Amendment
Customer No.: 24498
Serial No. 10/797,682
Page 5

Remarks/Arguments

Appln. No. 10/797,682
 Amendment Dated Reply to Office Action of 06/16/2005
ANNOTATED SHEET SHOWING CHANGES

FIG. 3

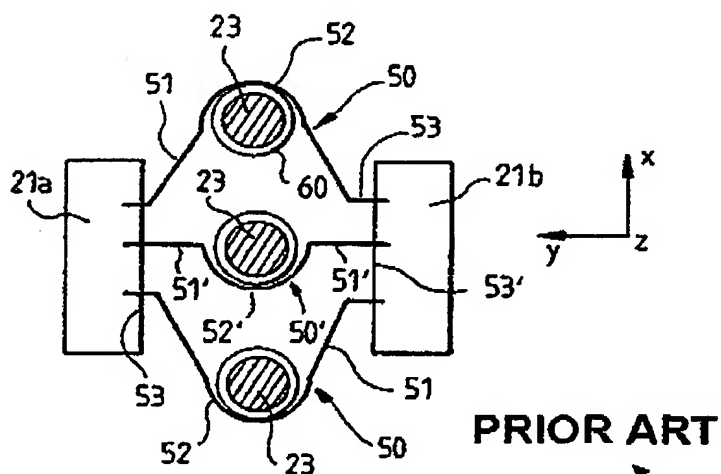
In response to the objection to Figures 3 and 4, Applicants amend Figures 3 and 4 to include the expression "Prior Art." Applicants respectfully request reconsideration of the objection.

Expression "PRIOR ART"
 Added
